**Section 12A Application No. Y/I-DB/2
Area 6f, Lot 385 RP & Ext (Part) in D.D. 352, Discovery Bay**

Objection to the Submission by the Applicant on 27.10.2016

Comments on the Third Submission by Masterplan Limited dated 26th October 2016 to Amend Discovery Bay Zoning Plan for Rezoning the permissible use from staff Quarters to Flats At Area 6f, Discovery Bay

Fig. 1.1 BEFORE & AFTER IMPRESSION FROM PLAZA

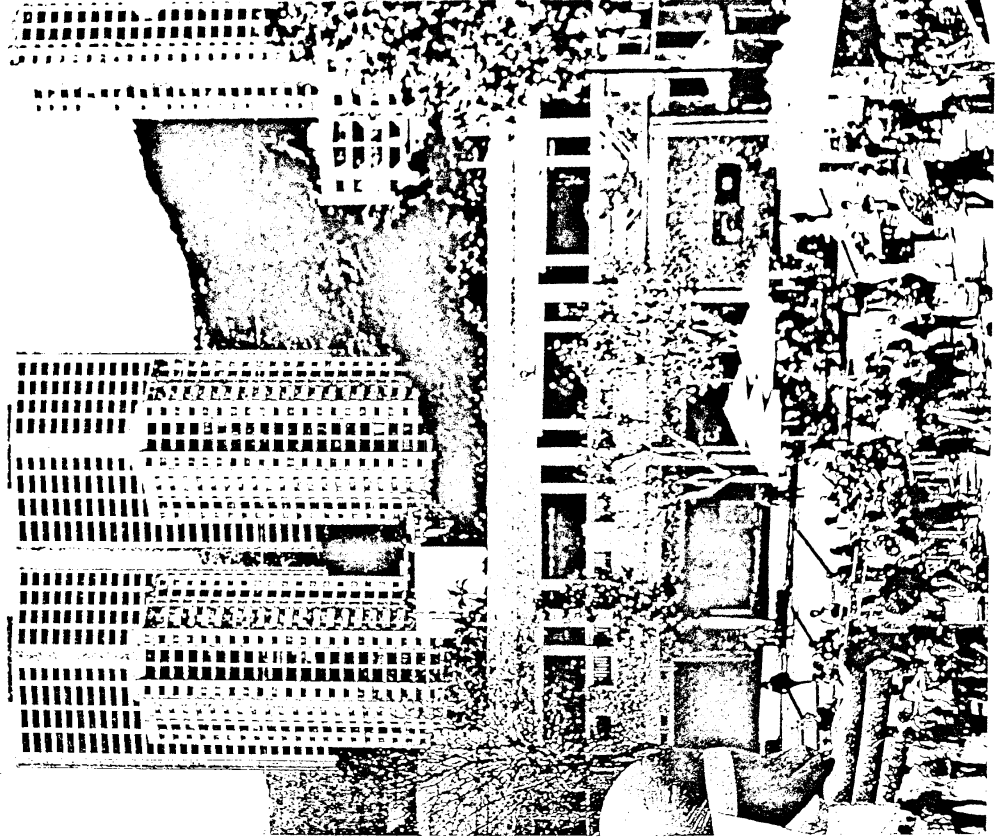
b. Figure B.9 view from DB Plaza – these poor quality photomontages hardly reflect the views from the Plaza on a clear day as illustrated in the VOC photos in Annex 1 to this submission.

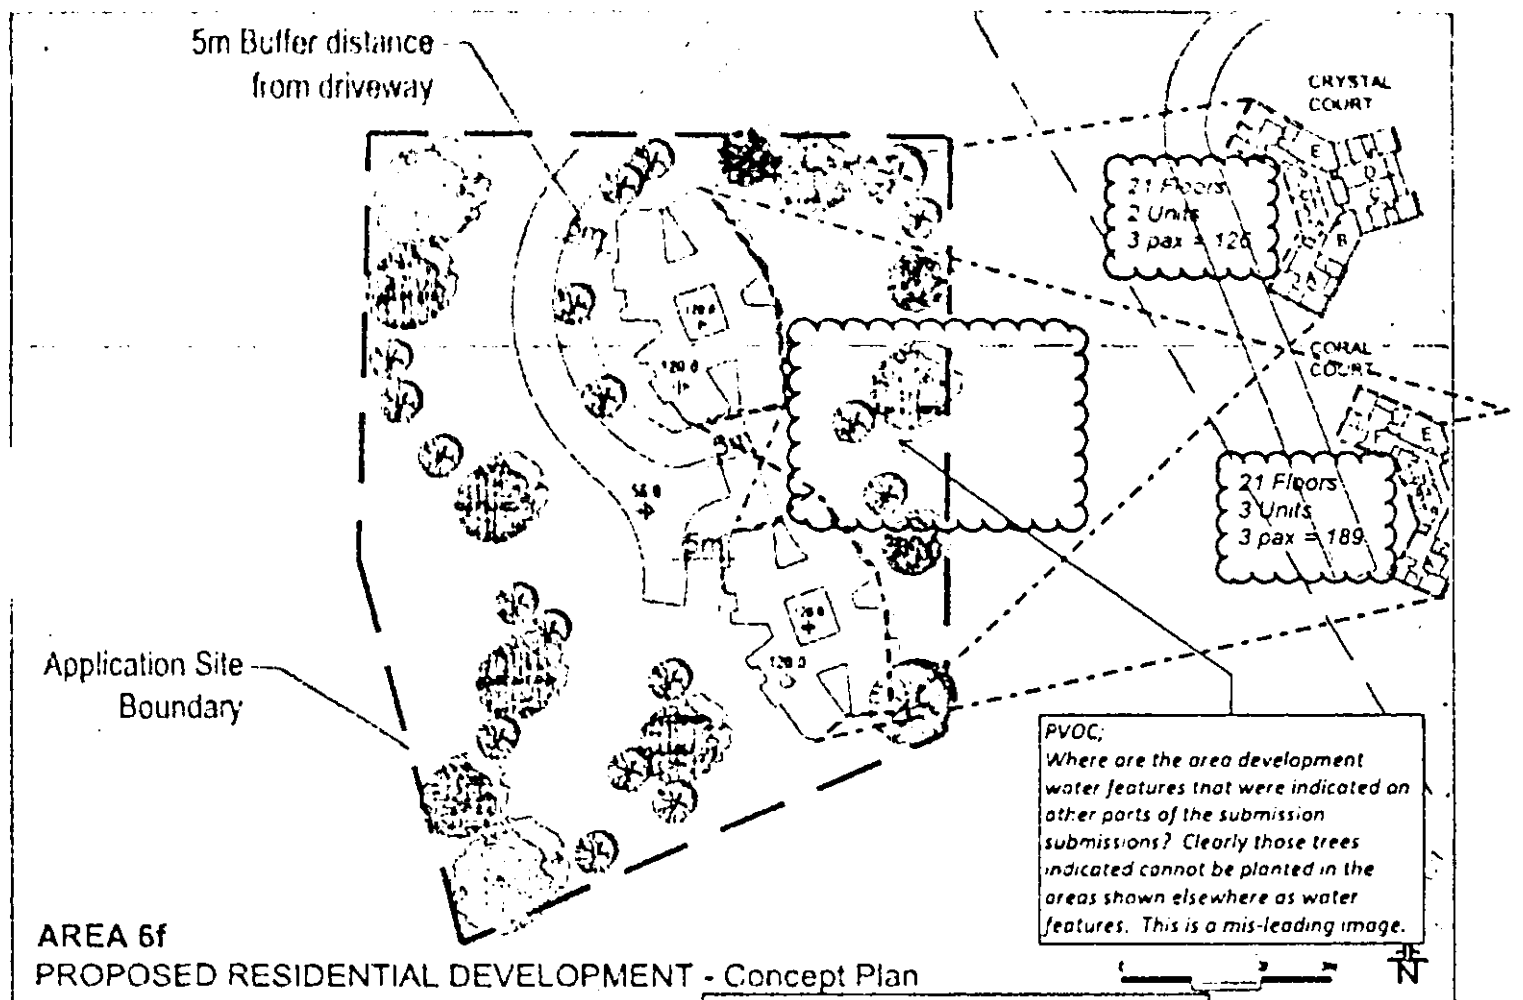
PVOC;
Please confirm where the responses are to the Residents / PVOC concerns as they do not appear to have been reviewed or addressed.

PVOC;
Photo-montages are very poor quality, and are not reflective of the view from the majority of the community.

TITLE	LANDSCAPE MASTER PLAN	REV. 0 OCTOBER 2004	PAGE B.1
PROJECT	DISCOVERY BAY OPTIMIZATION OF LAND USE - AREA 6F

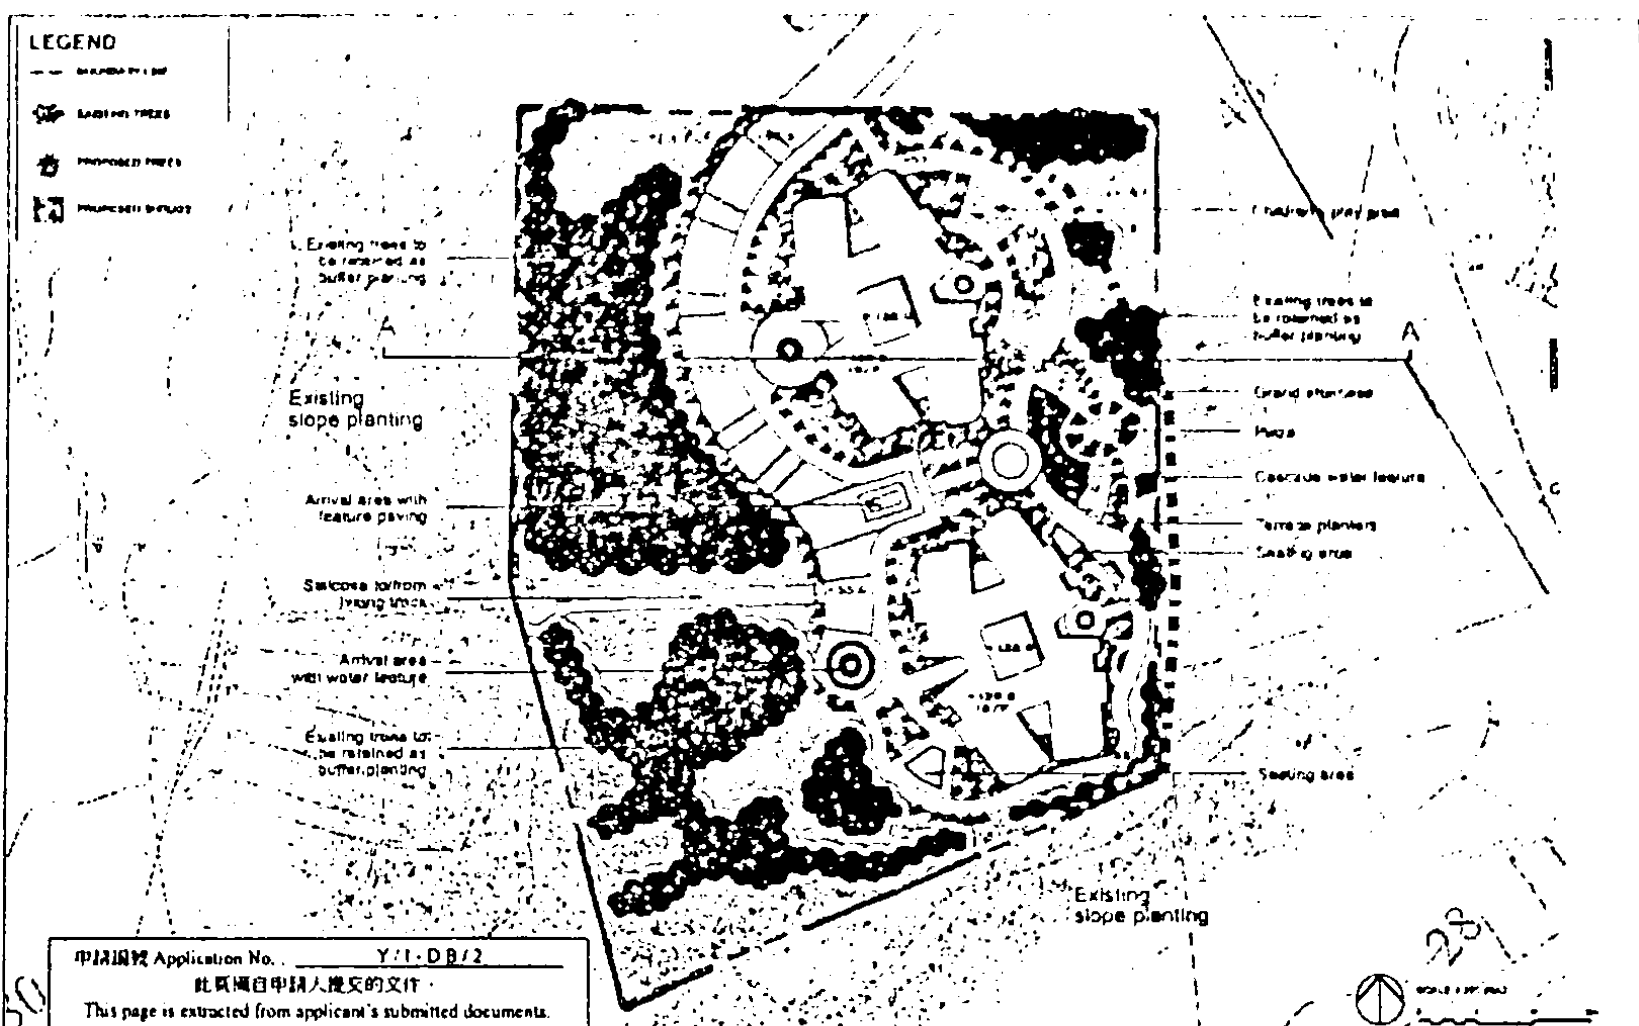
a. Tree Treatment Plan (Annex B, page A3) and Optimisation of Land Use figure B.1. The statement about existing tree groups to be retained is incorrect. These trees cannot be maintained based on the current plan, as there is a requirement for a large retaining structure and site formation that would not allow these trees to be left in place. Simple construction logistics would mean this would be very improbable. Also where is the approximate location of the retaining wall? The excavation for construction will remove those highlighted trees.

VP12 View West (from 2012 Application) - 2012 Application

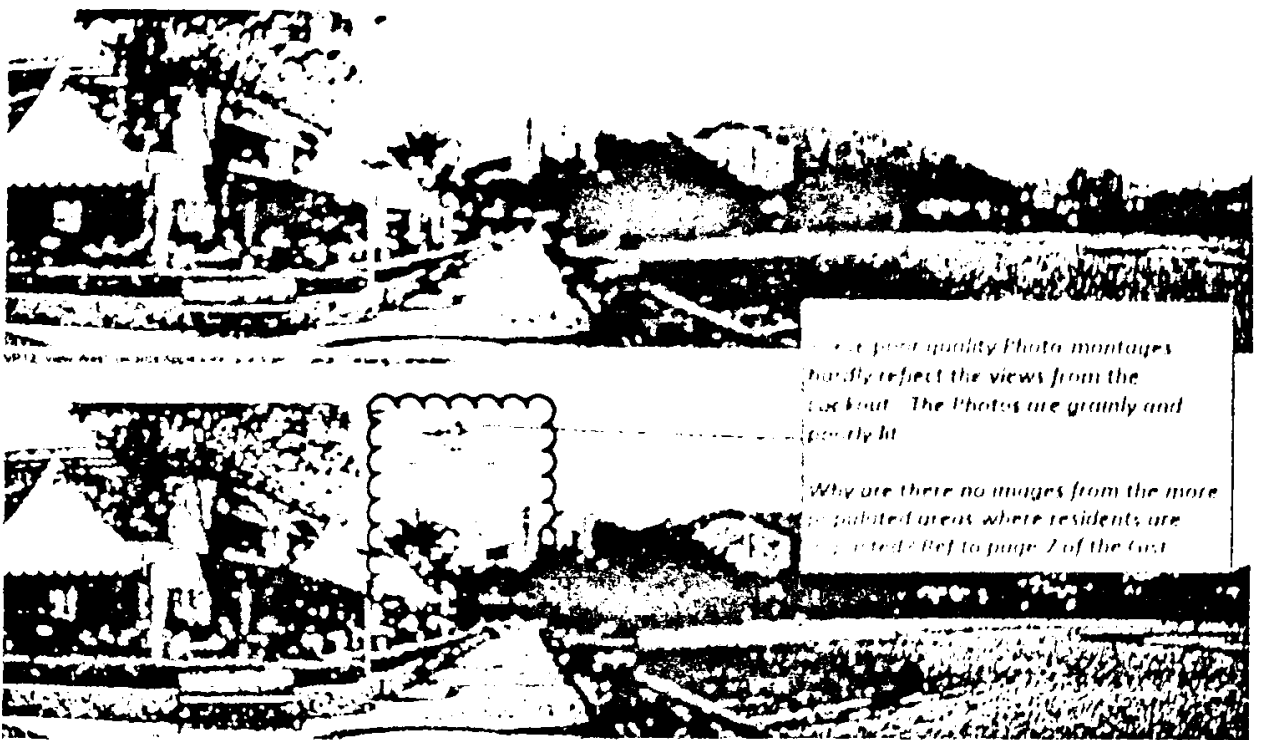
- e. Figure B.14 view from the D-Deck – why show this when there should be images from the more populated areas where residents are impacted, such as from Coral Court, Crystal Court, Woodbury Court, Woodgreen Court and Woodland.

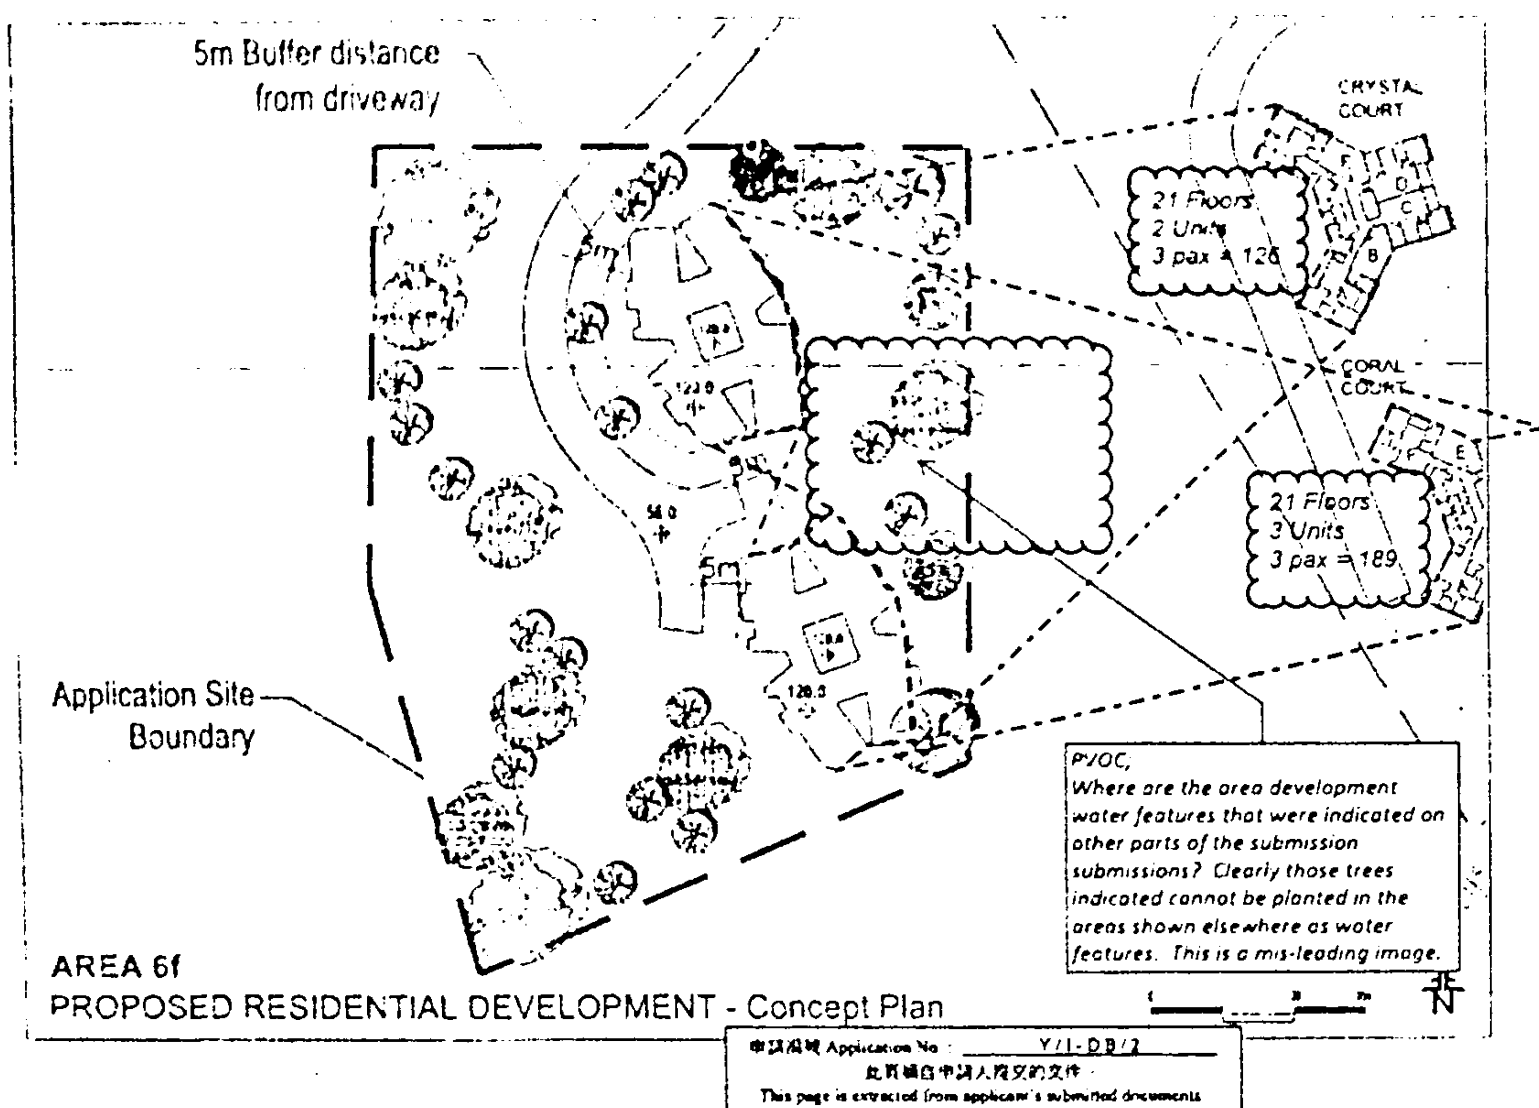
PVOC;
Please confirm where the responses are to the Residents / PVOC concerns as they do not appear to have been reviewed or addressed.

PVOC;
Photo-montages are very poor quality, and are not reflective of the view from the majority of the community.
